RE: CONCEPTUAL GRADING & DRAINAGE REPORT FOR TURQUOISE TREE SQUARE  
SUBMITTED NOVEMBER 2, 1987 FOR SITE DEVELOPMENT APPROVAL  
(G-11/D43)

# Conceptual Grading & Drainage Plan

**TURQUOISE TREE SQUARE**  
COORS BLVD. & REDLANDS RD.  
ALBUQUERQUE, NEW MEXICO  
**GRADING AND DRAINAGE**

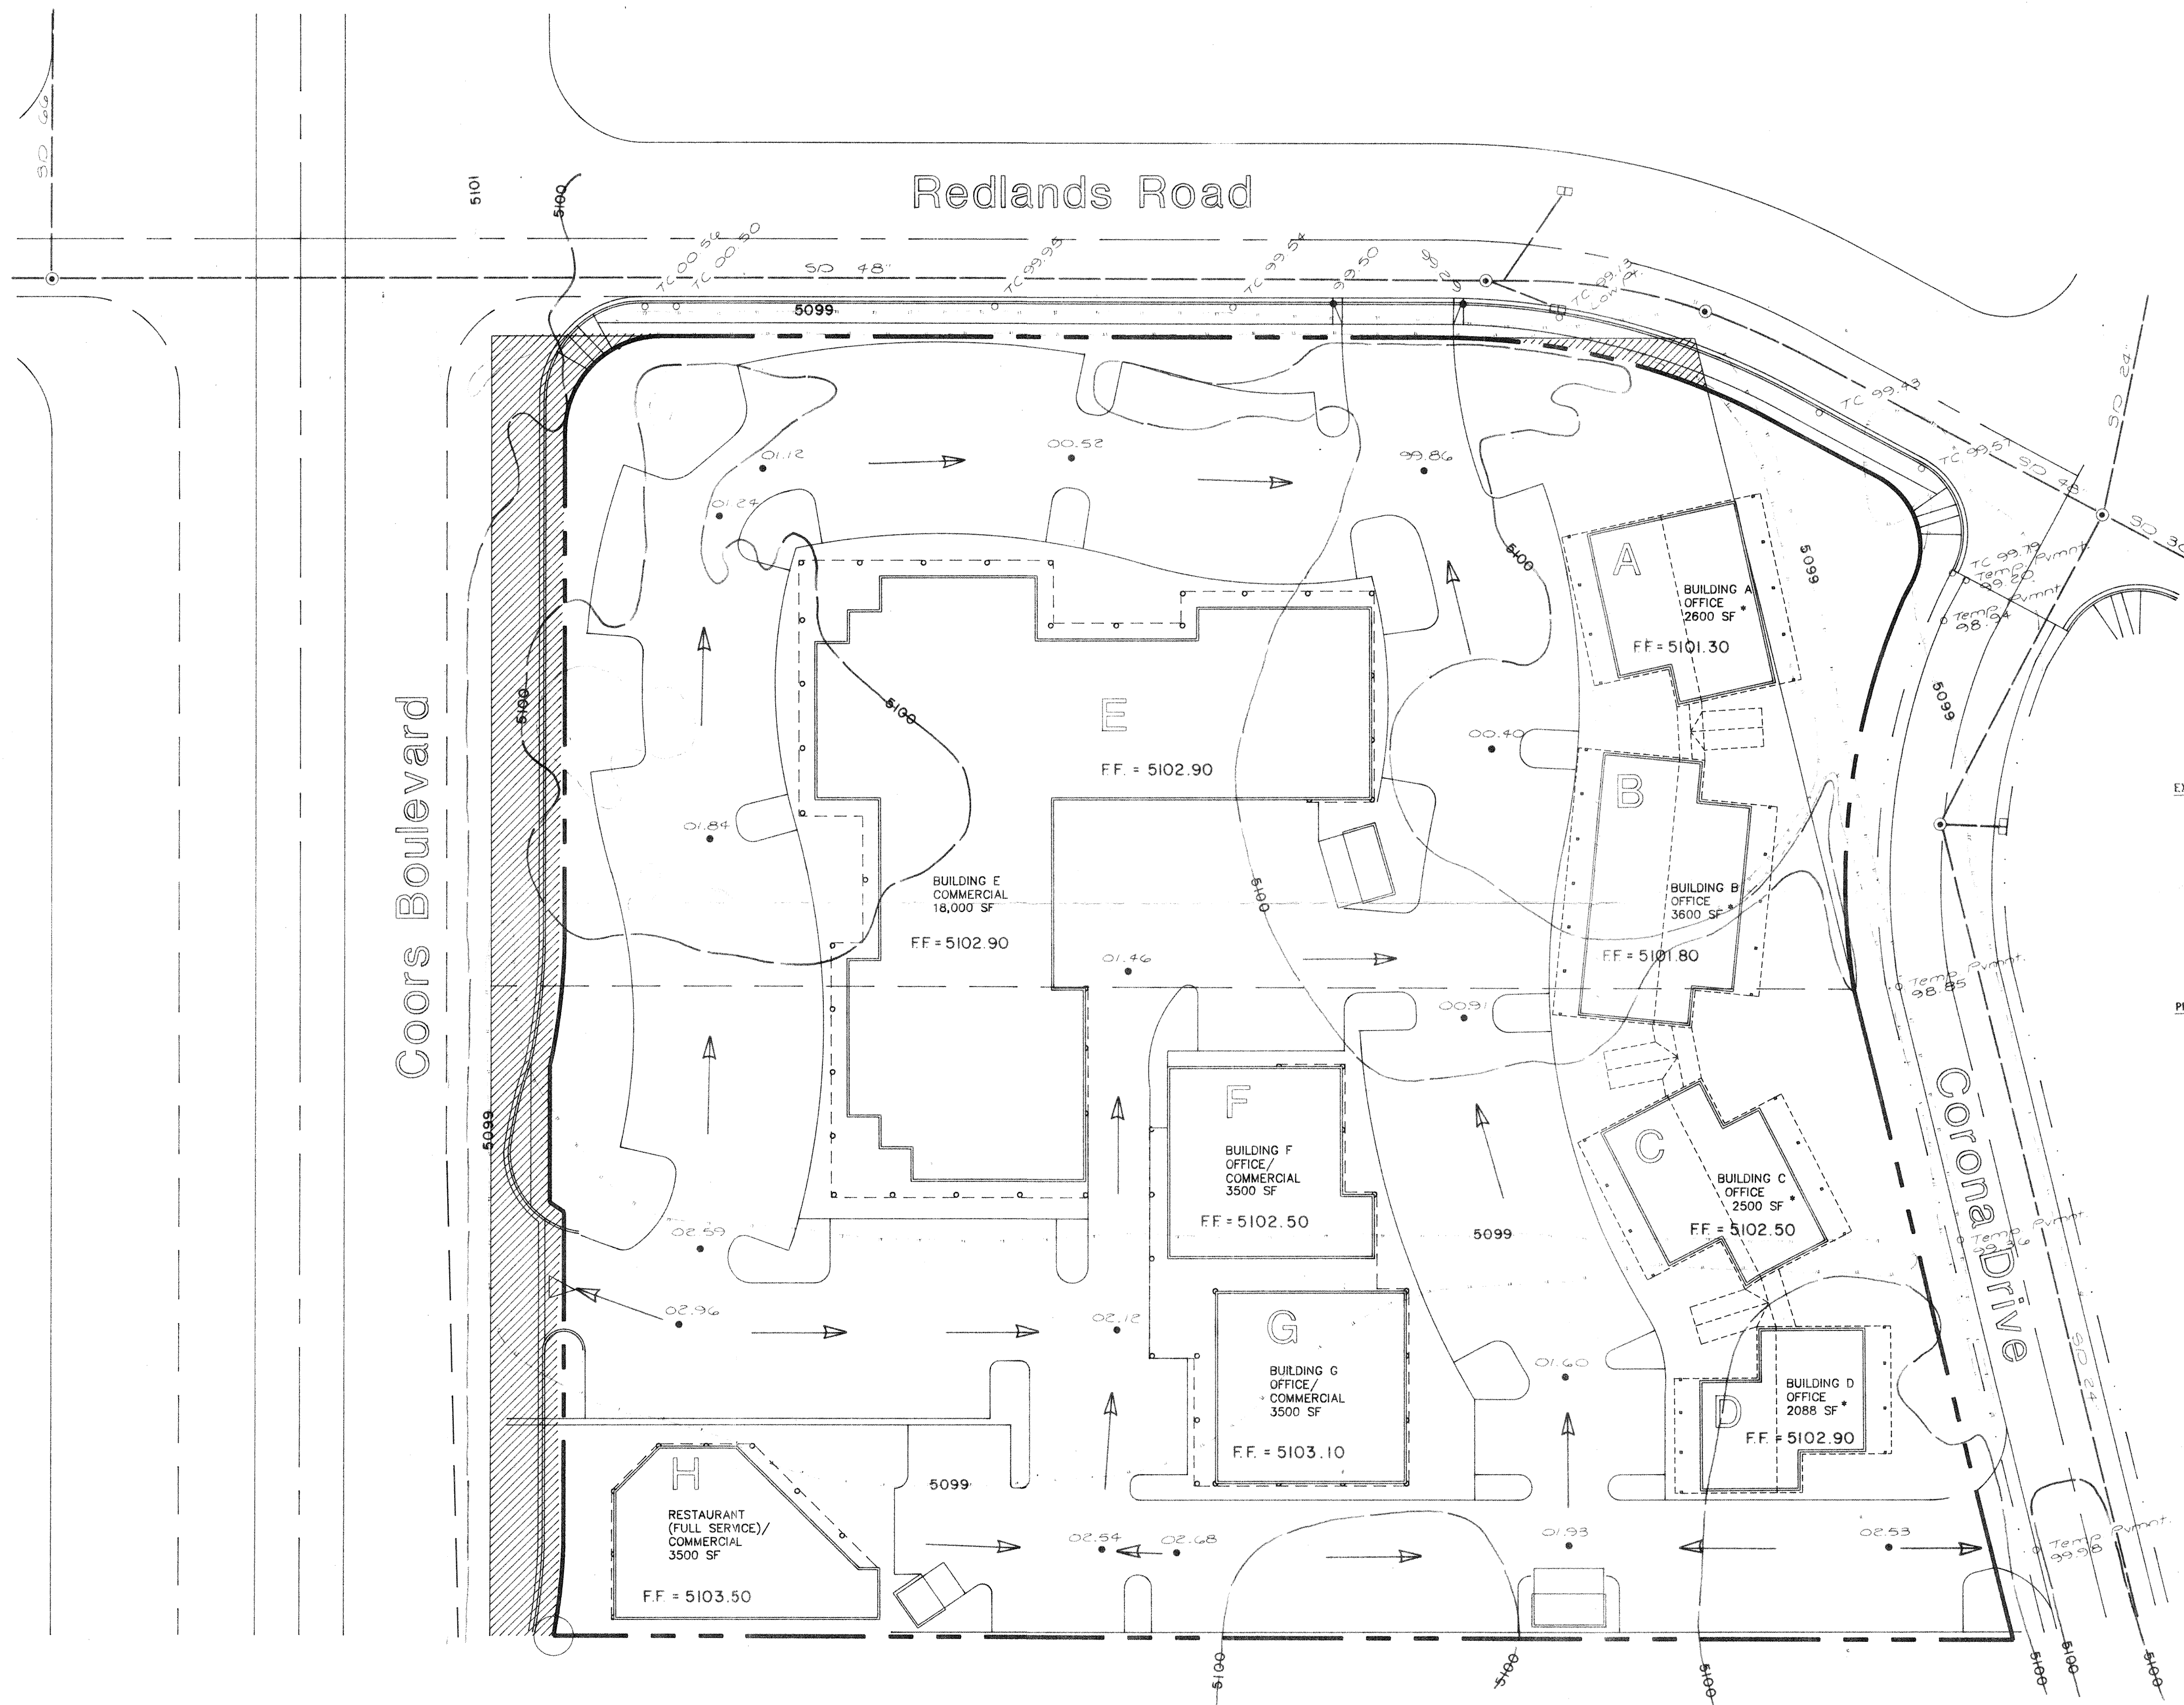
Your plan to grade the site for free discharge to Redlands Road is acceptable. What you must address, however, is the drainage of the lots directly adjacent and to the south, which seem to drain onto your client's land.

If the new (proposed) street grades on Pheasant will allow these lots to drain to the south, or, if the owner(s) of these lots indicate their plan to add fill to force their lots to drain to the south, you will not have to accept any off-site flows from this area. Otherwise, you will need to make allowances to accept the flows from the south if this is the historic drainage path.

PROJECT NO.  
SHEET NO.  
**C3**

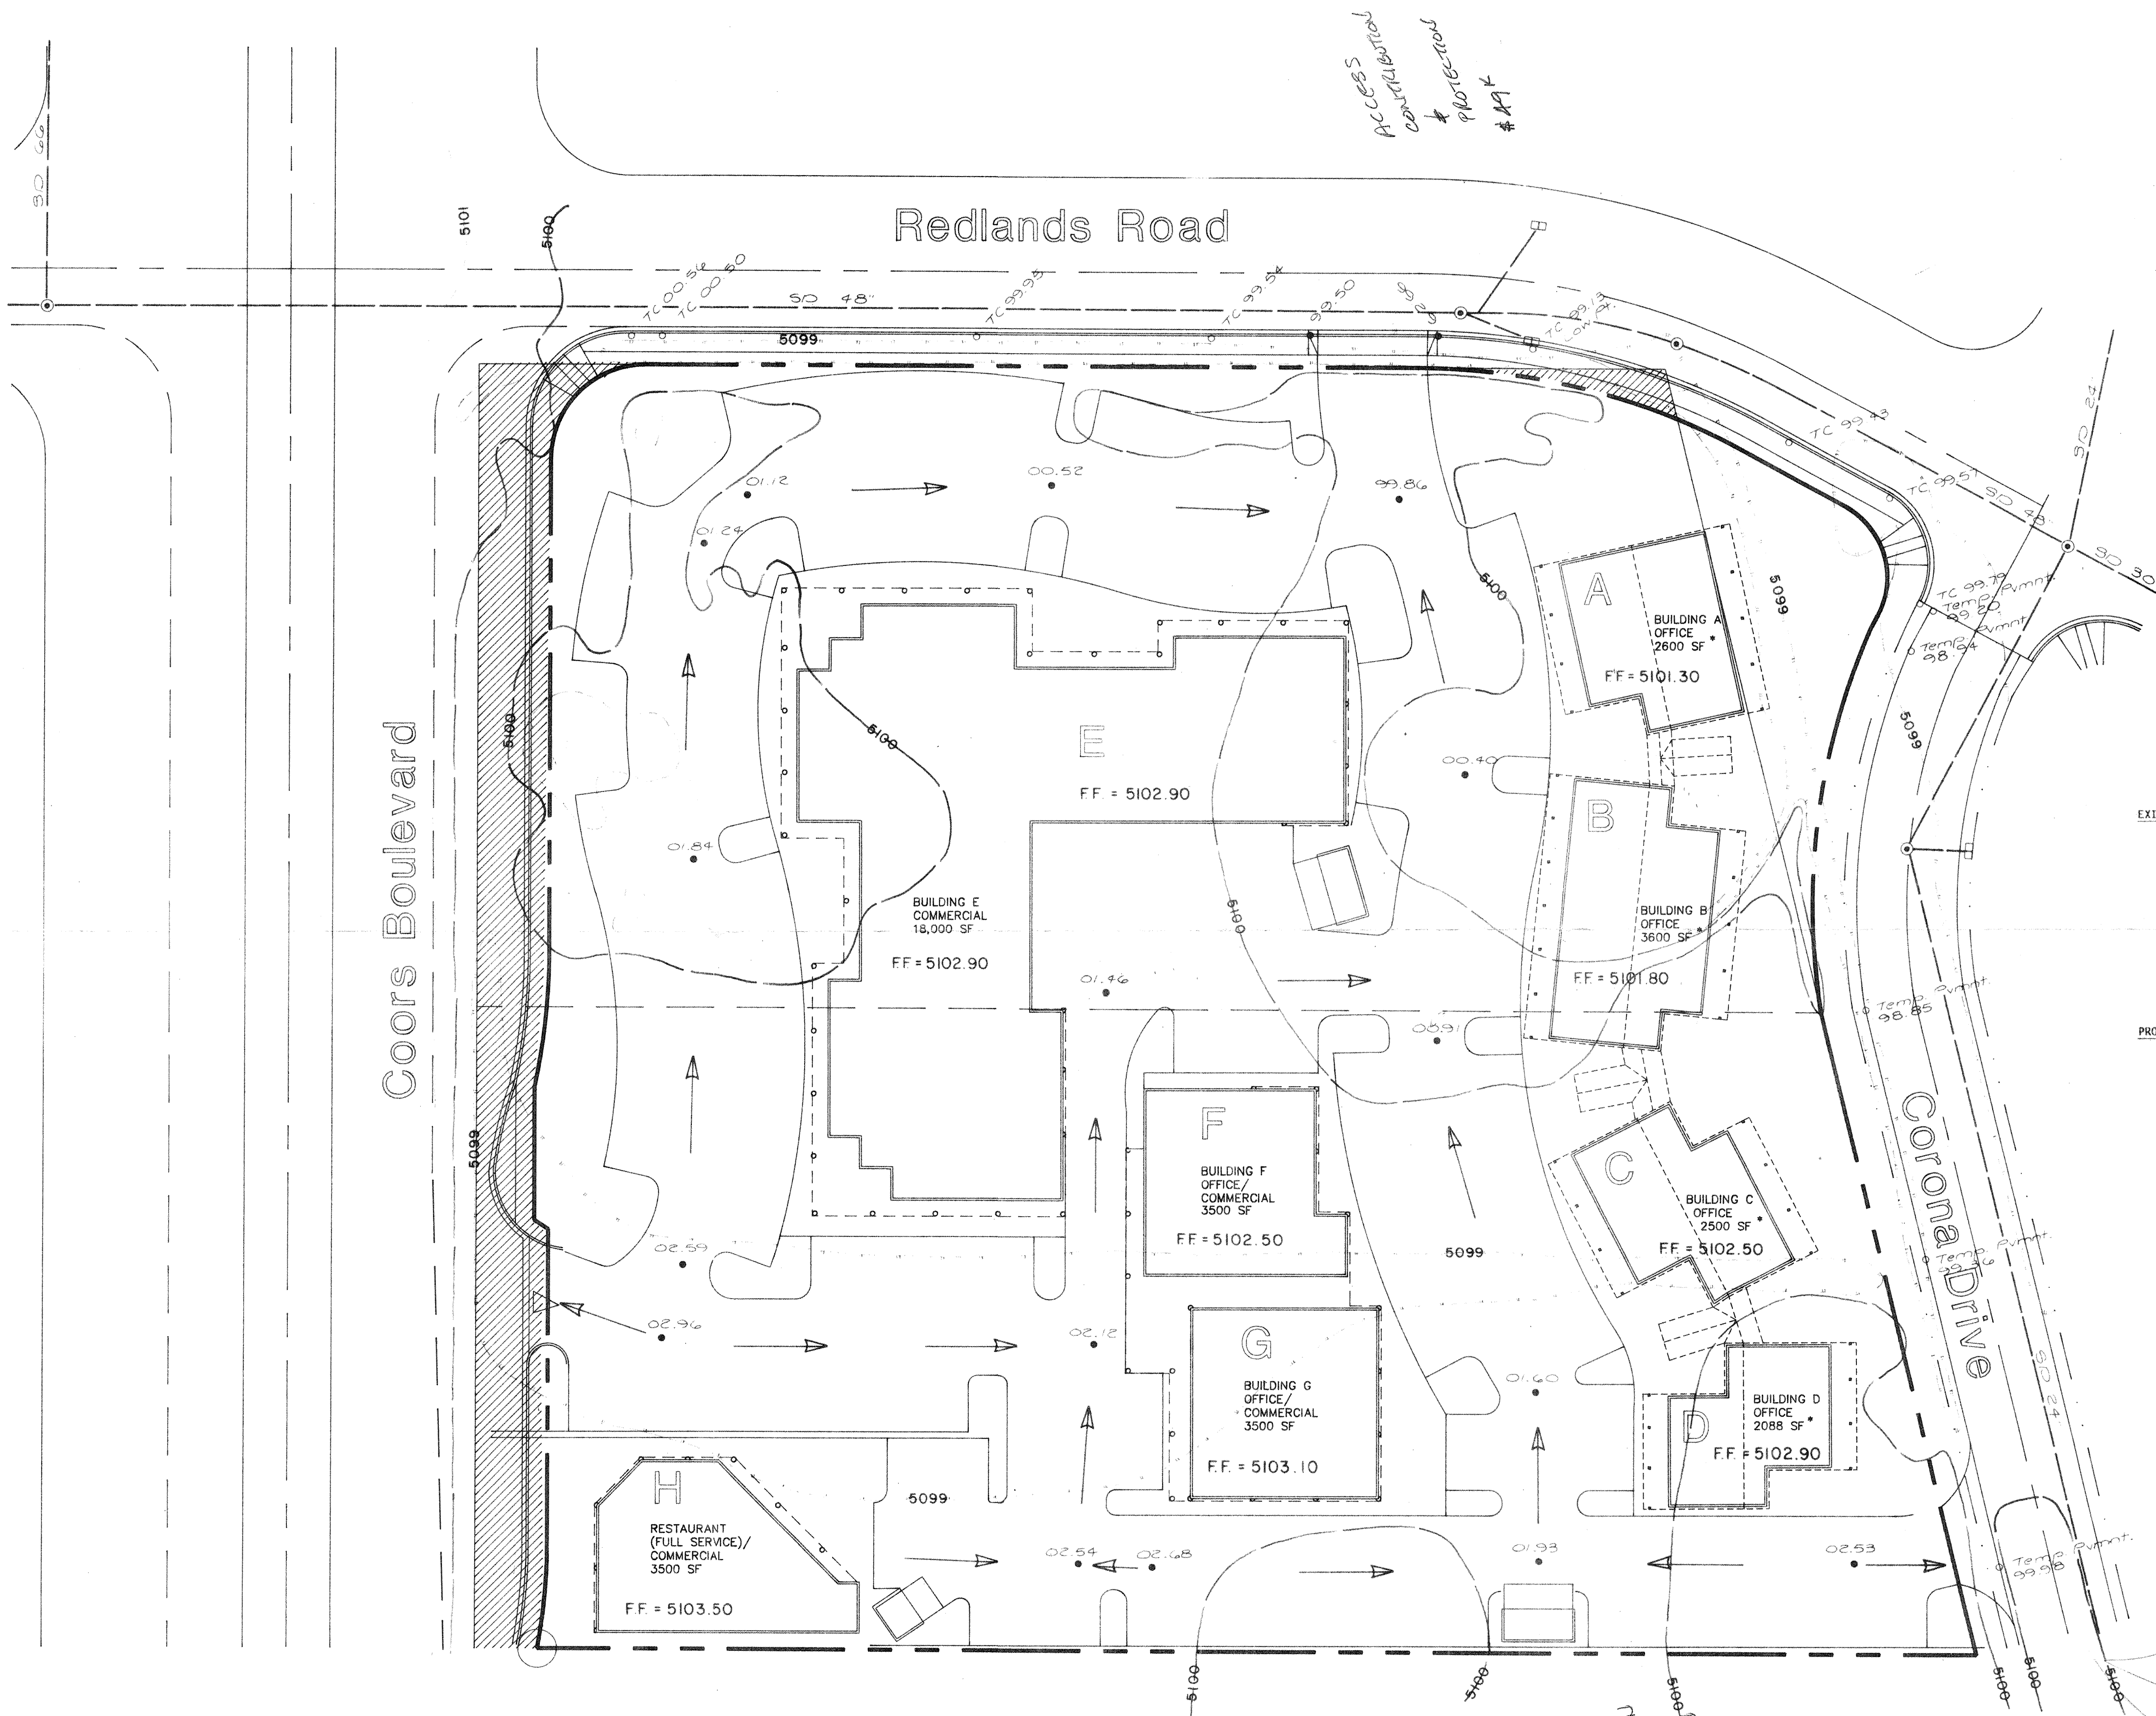
Your plan to grade the site for free discharge to Redlands Road is acceptable. What you must address, however, is the drainage of the lots directly adjacent and to the south, which seem to drain onto your client's land.

If the new (proposed) street grades on Pheasant will allow these lots to drain to the south, or, if the owner(s) of these lots indicate their plan to add fill to force their lots to drain to the south, you will not have to accept any off-site flows from this area. Otherwise, you will need to make allowances to accept the flows from the south if this is the historic drainage path.
